**Pendleton Office**

**Addendum #2**

Pendleton Office  
Addendum No. 2  
Date: August 11, 2025

**Date:** 08/08/25  
**Client:** SRA  
**Project:** Pendleton Park  
Hemphill, Texas  
**Project No.:** 21.095

B1 SF SILL @ 8" PEMB / MTL WALL PANEL  
A403 SCALE: 3" = 1'-0"

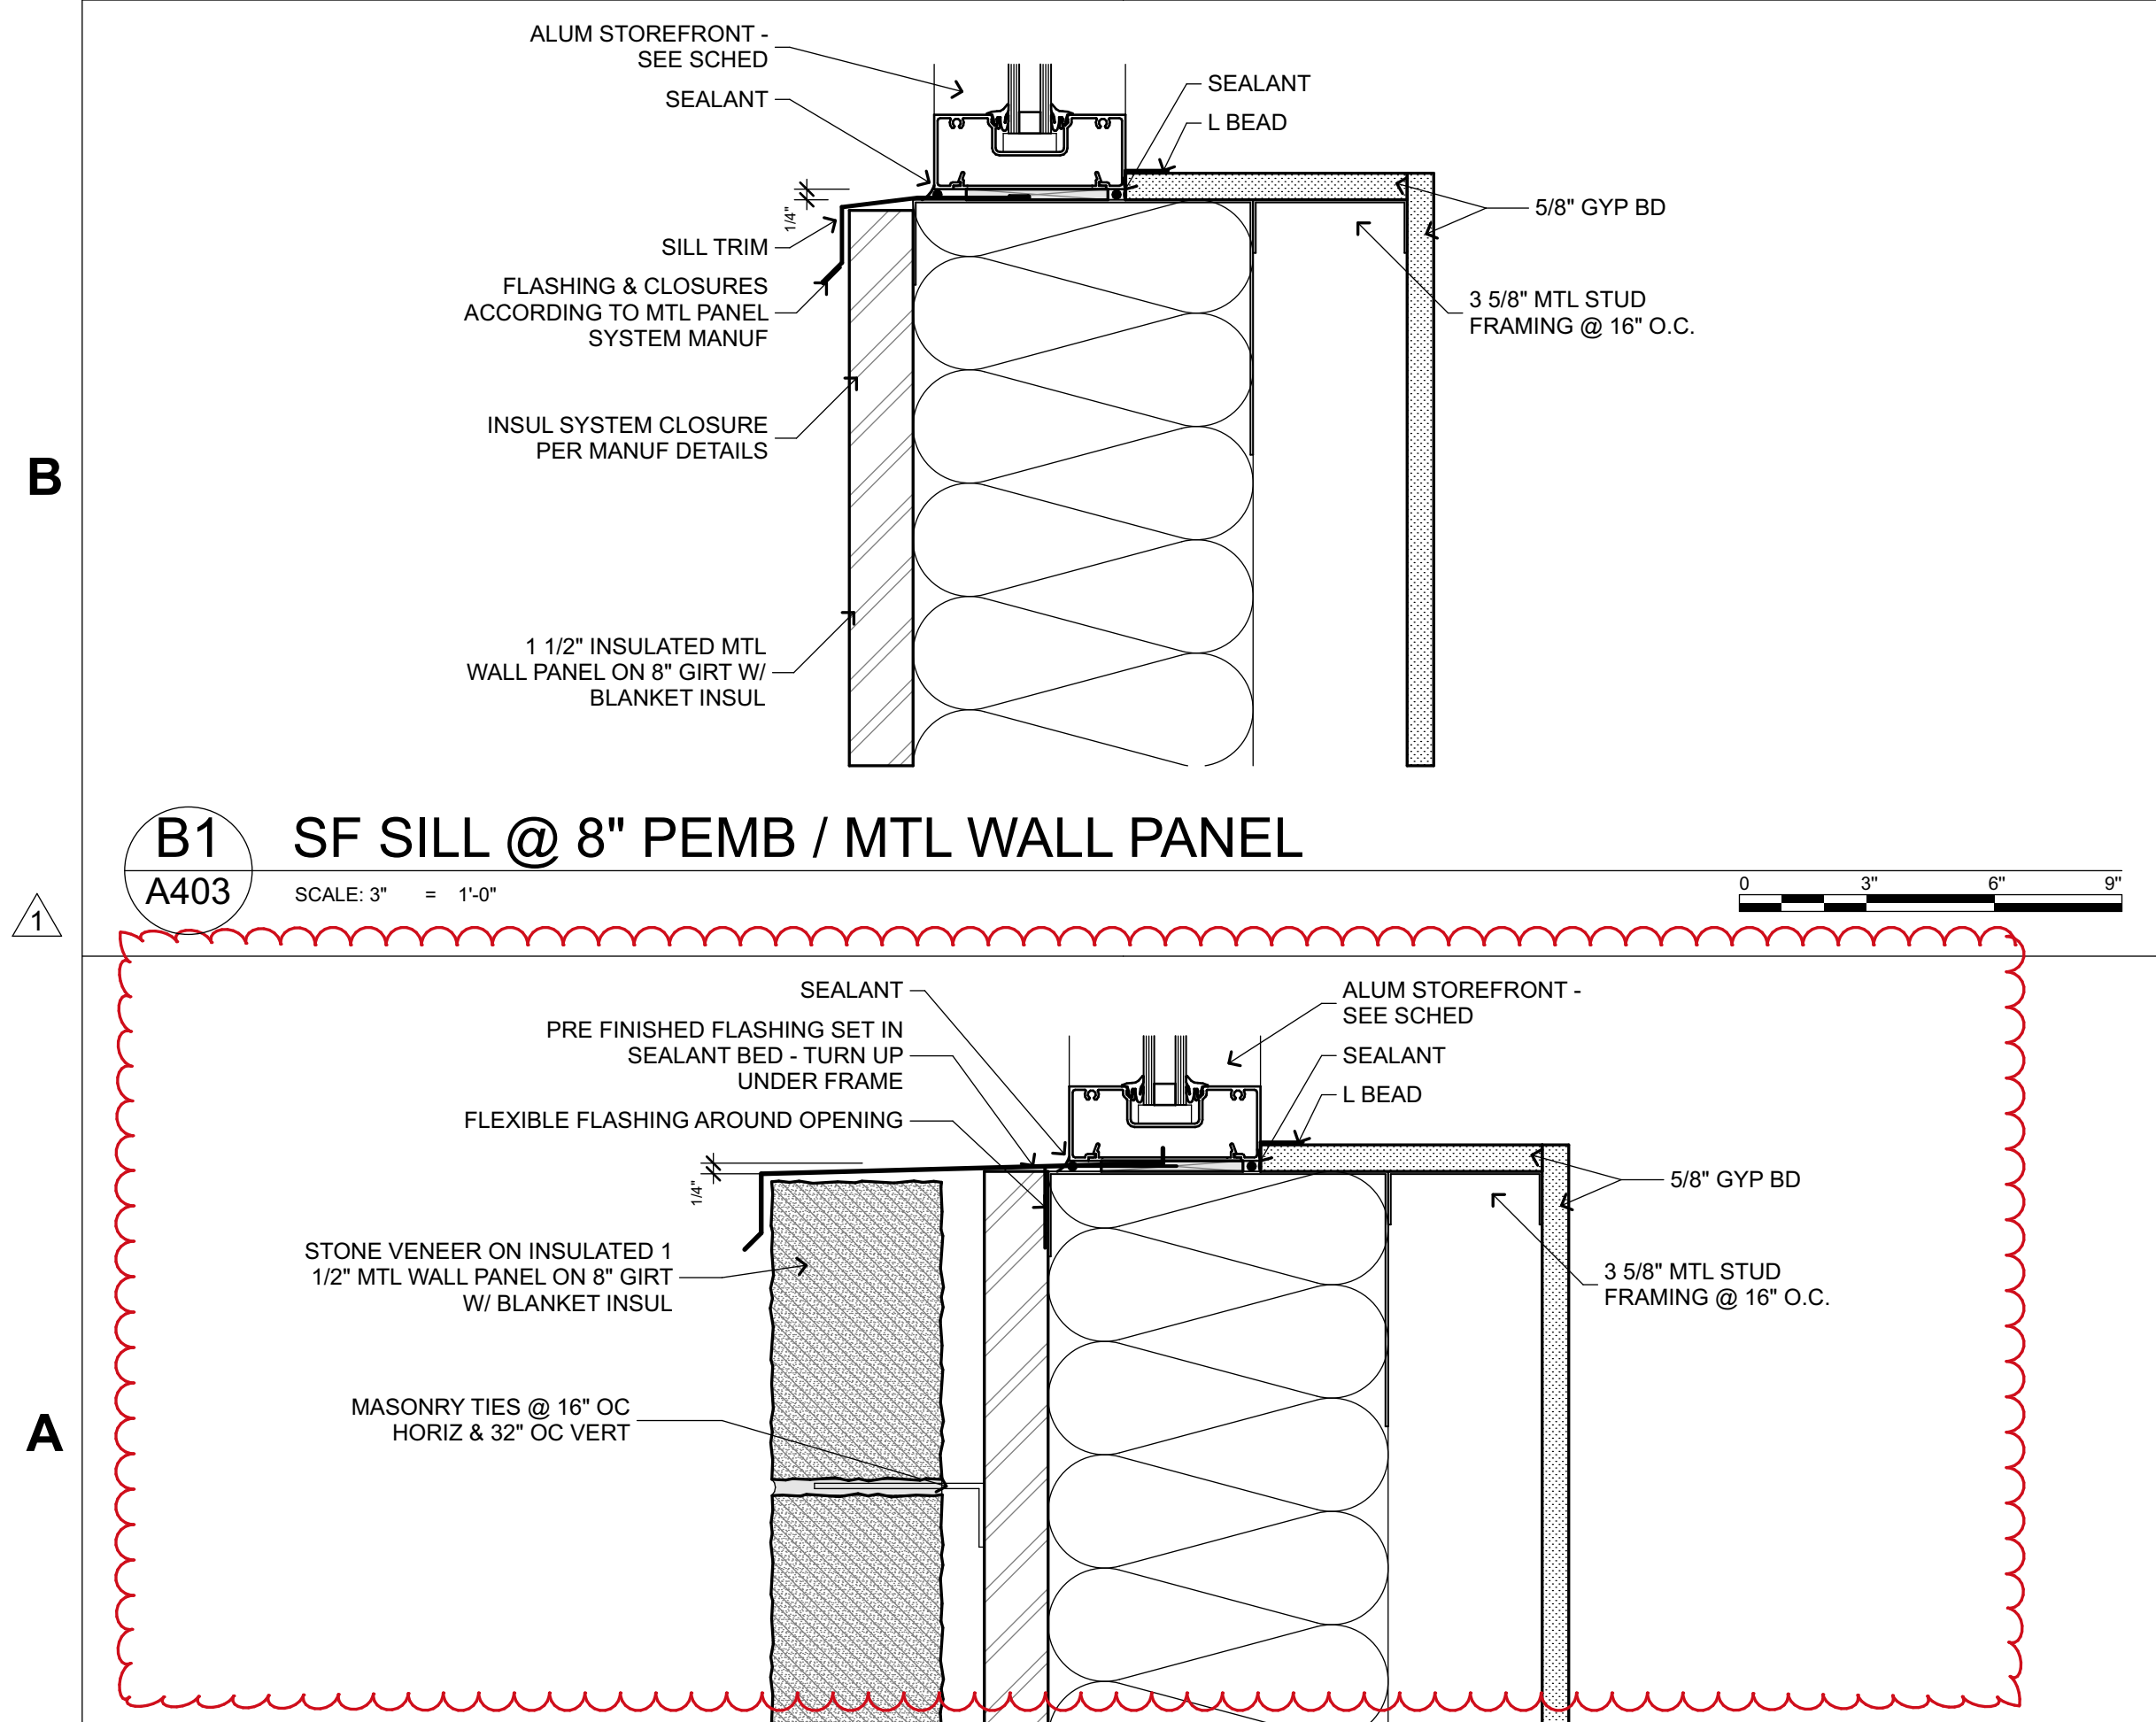
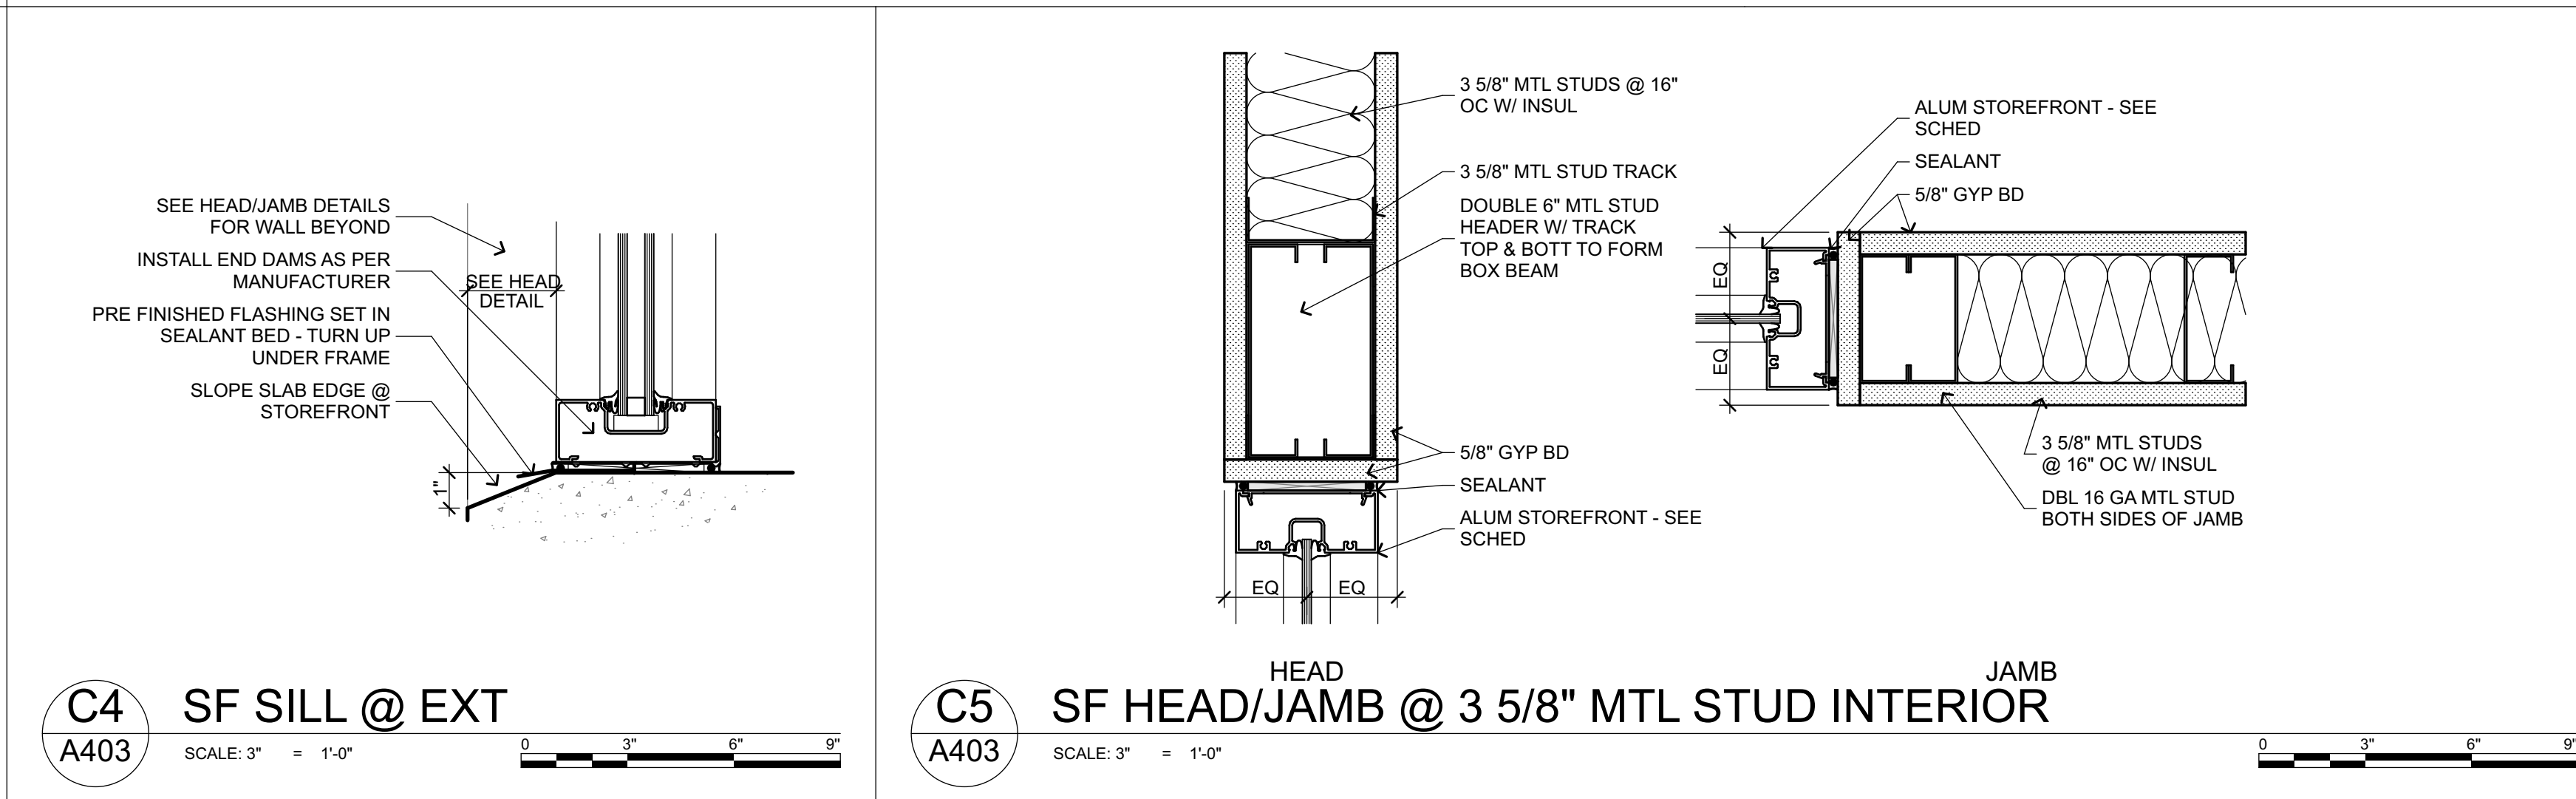
ITEM 1.06. A403 – REVISION Note added to window schedule for manual roller shade location clarification. Note added to window details for clarification. Metal panel is insulated as specified.

NOTES:  
1. HEAD/JAMB/SILL DETAILS PER PEMB MANUF  
2. MANUAL ROLLER SHADE

SHEET NUMBER  
**A701**

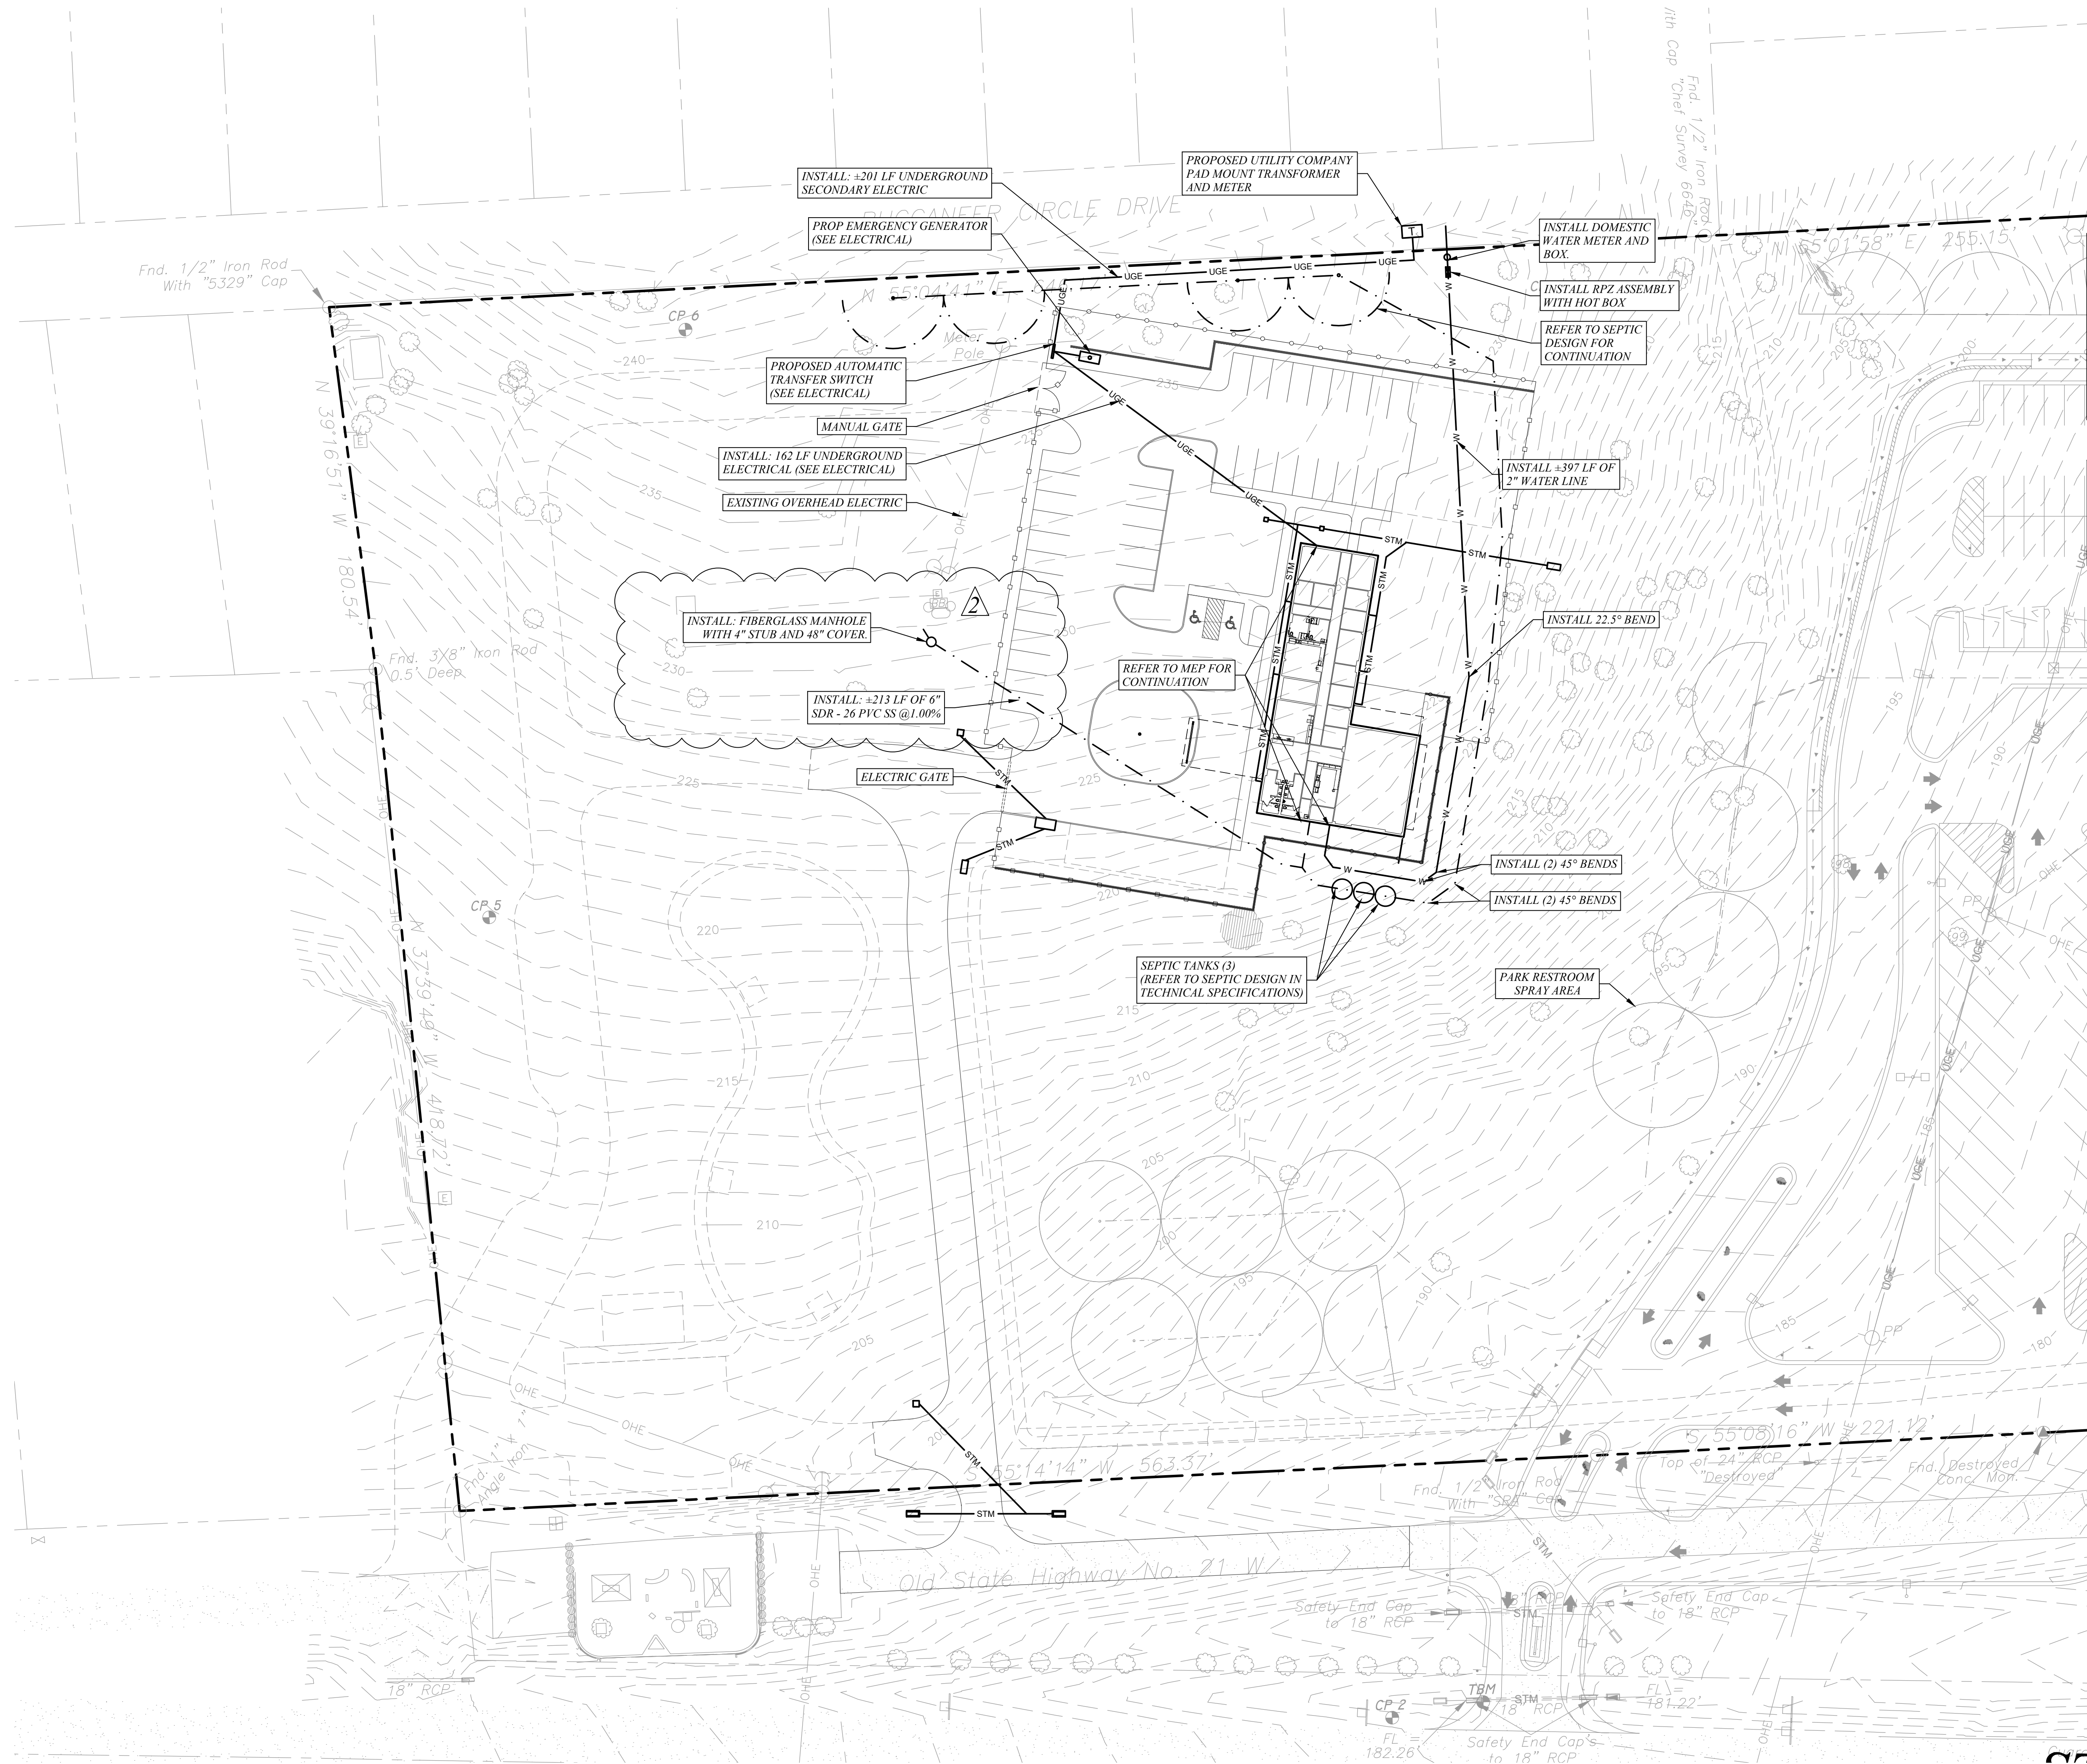
ITEM 1.07. A701 – REVISION Accent paint finish revised shown on interior elevations.
